Sparkle Knit Composite Limited

Kabirpur, Savar, Dhaka
(24.015723, 90.248490)
08 October 2023

Observations

Live load plan- typical floor

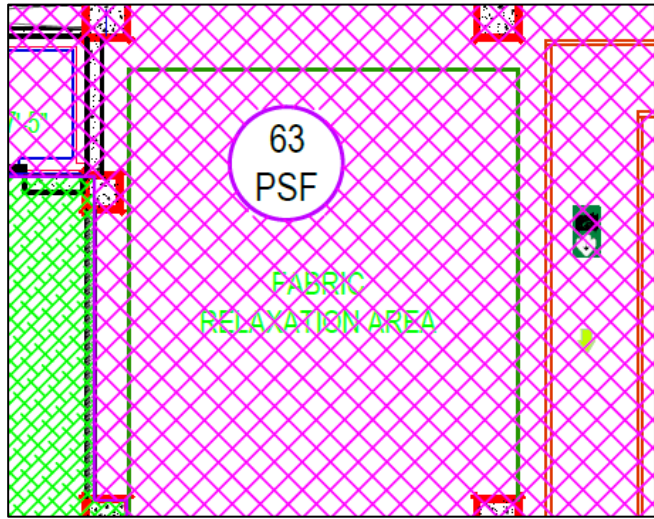
Live load considered as 3 KPa for storage areas

Live load on typical floor is considered as 3 kPa in prepared load plan. As per BNBC- Part 6, live load for light storage areas is required to be considered minimum 6 kPa. However, the factory engineer is required to revise the load plan as per BNBC requirement and check the design accordingly.

Lack of edge protection

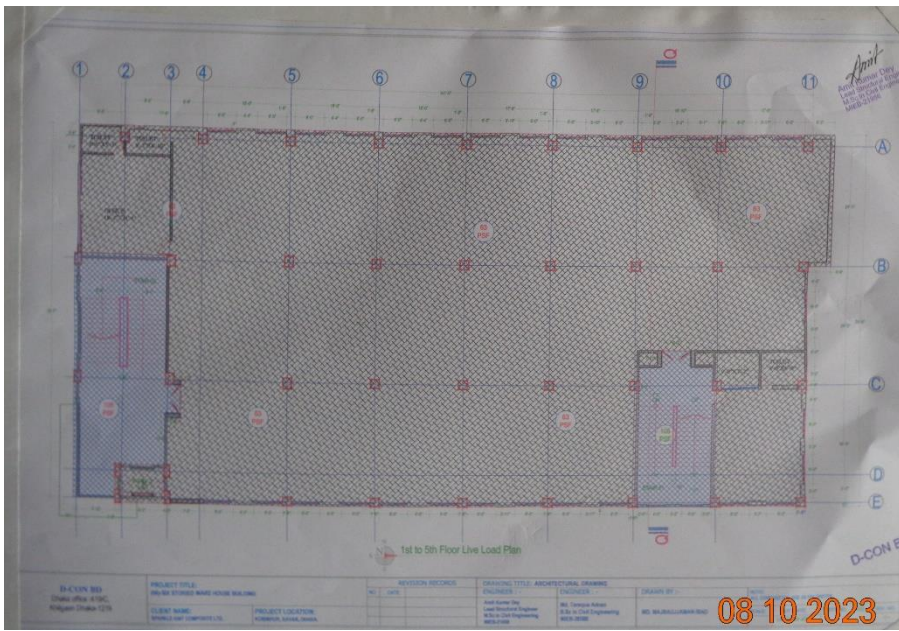
Parapet wall missing at roof

During inspection, Edge protection (Parapet wall/Railing) was not observed on roof and stair. Factory is required to provide edge protection to avoid falling hazard.

WTP Building

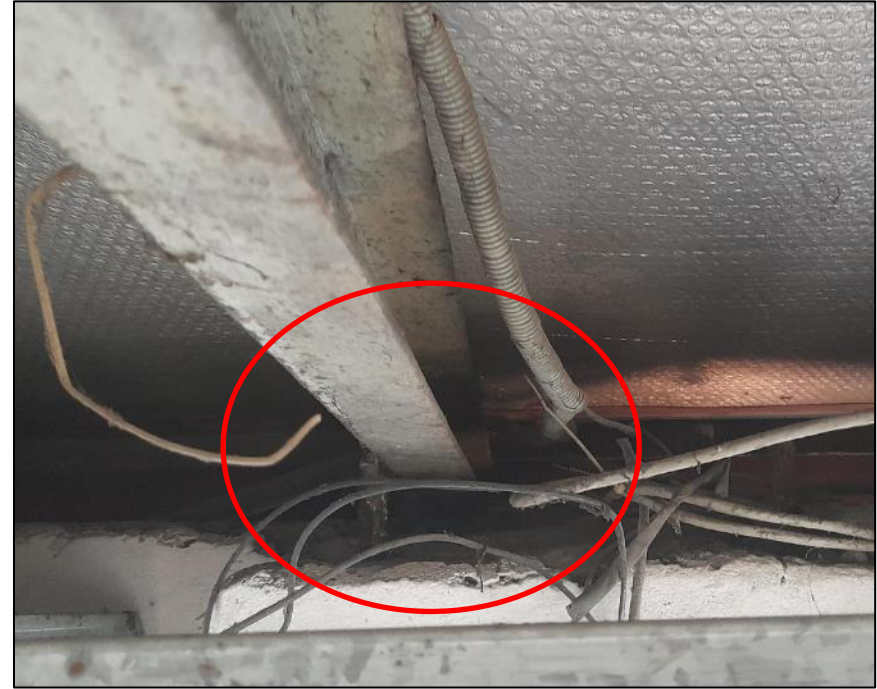
As per BNBC, every building or structure designed shall have its design documents prepared in accordance with the provision of Section 1.9.1. The design document shall include a design report, and a set of structural drawings, which shall be prepared in compliance with section 1.9.1.1 and section 1.9.1.2 as per BNBC. At the time of inspection, design report was not available which is required to be prepared in compliance with section 1.9.1.1 (part-6, BNBC).

Corrosion in steel section

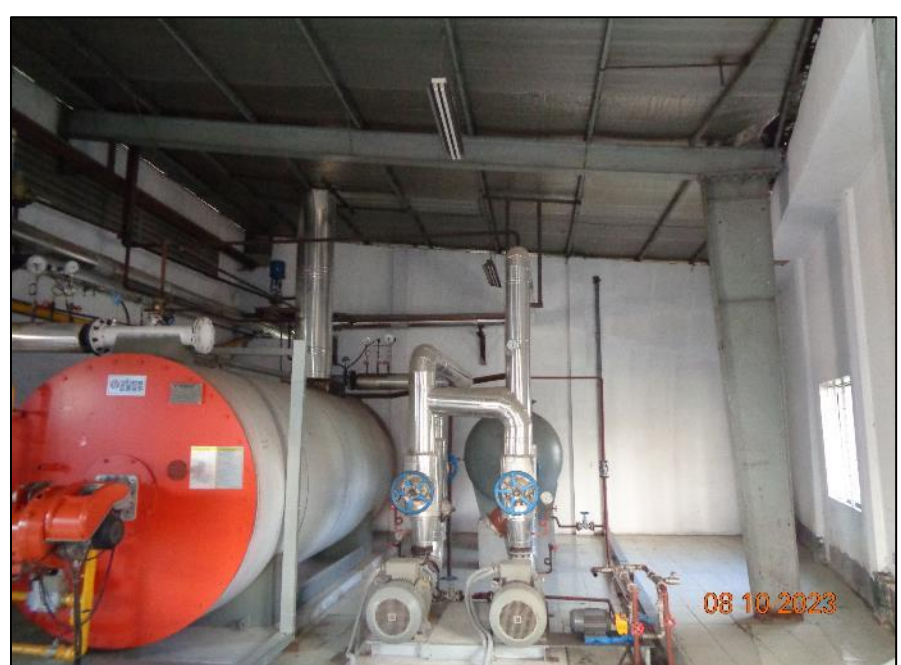
Corrosion in steel section

During inspection, corrosion was observed in steel section. Factory engineer is required to take necessary measures to prevent the corrosion in steel sections.
